Product Termination Notification

Product Group: DIODES / January 14th, 2015 / PCN-DD-002-2015 Rev.0

Product Discontinuation for Surface Mount Schottky Products

Label

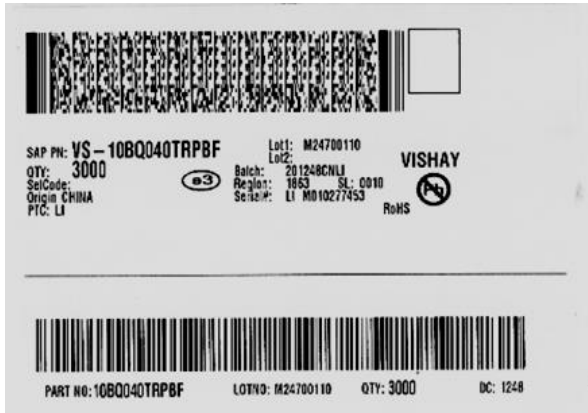
Current (Combined 2D+1D)

New (Separated 2D and 1D)

Device marking

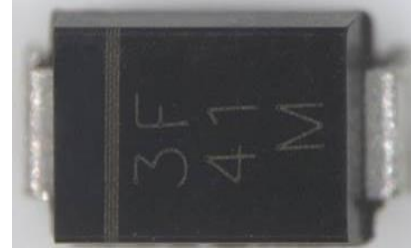
Current

New

Package Outline Dimension

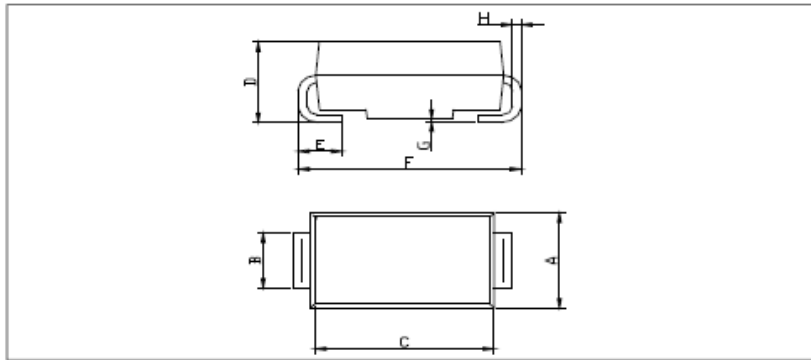
DESCRIPTION OF CHANGE: Discontinuation of part numbers.
 Alternatives part numbers will be manufactured in Vishay in house factory in Tianjin China.
 Package Outline Dimension will be slightly different but still meeting JEDEC specification tolerances.
 Details of changes of device marking, label, packaging and MOQ are shown from page 4 to 6.
 Together with the back-end assembly location and structure changes the Silicon Wafer diameter used as raw material will change from 5 inches (125 mm) to 6 inches (150 mm).
 Taking the chance of the listed changes to be implemented in this PTN, Vishay Diodes will also launch the AEC Q-101 qualified corresponding material with HM3 code

SMA	Unit:mm	A	B	C	D	E	F
New	Spec	2.54~2.79	1.24~1.65	3.99~4.50	1.98~2.29	0.76~1.52	4.93~5.28
	Typical value	2.63	1.57	4.28	2.09	1.06	5.12
Current	Spec	2.55~2.65	1.46~1.54	4.15~4.25	1.97~2.03	0.87~1.13	4.98~5.18
	Typical value	2.6	1.5	4.2	2	1	5.08

SMB	Unit:mm	A	B	C	D	E	F
New	Spec	3.30~3.94	1.96~2.18	4.06~4.57	2.13~2.44	0.76~1.52	5.21~5.59
	Typical value	3.56	2.07	4.53	2.19	1.06	5.31
Current	Spec	3.45~3.55	1.92~2	4.35~4.45	2.13~2.19	0.87~1.13	5.26~5.46
	Typical value	3.5	2	4.4	2.16	1	5.36

SMC	Unit:mm	A	B	C	D	E	F
New	Spec	5.59~6.22	2.90~3.20	6.6~7.11	2.06~2.62	0.76~1.52	7.75~8.13
	Typical value	5.84	3.12	6.73	2.24	1.14	7.92
Current	Spec	5.75~5.85	2.96~3.04	6.75~6.85	2.13~2.19	1.01~1.27	7.77~7.97
	Typical value	5.8	3	6.8	2.16	1.14	7.87
